04-357r1 SAS-1.1: Another Port Selector Detection Gap

To: T10 Technical Committee
From: Robert Sheffield, Intel (robert.l.sheffield@intel.com)
Date: 10 November 2004
Subject: 04-357r1 SAS-1.1: Another Port Selector Detection Gap

Figure 85 — SP (phy layer) state machine - OOB sequence states

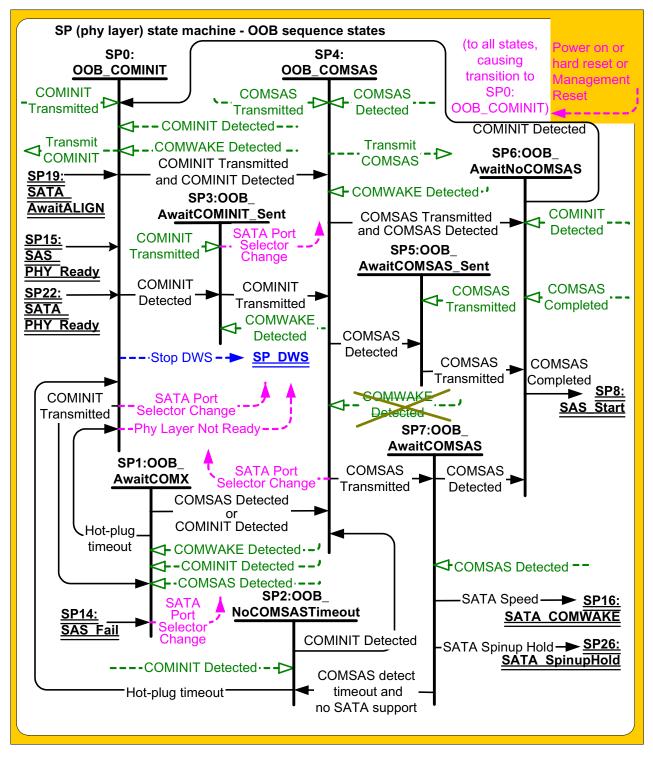
This proposal also includes an editorial change to Figure 85 - SP (phy layer) state machine - OOB sequence states to remove a duplicate incomming message, COMWAKE detected, in SP4:OOB_COMSAS.
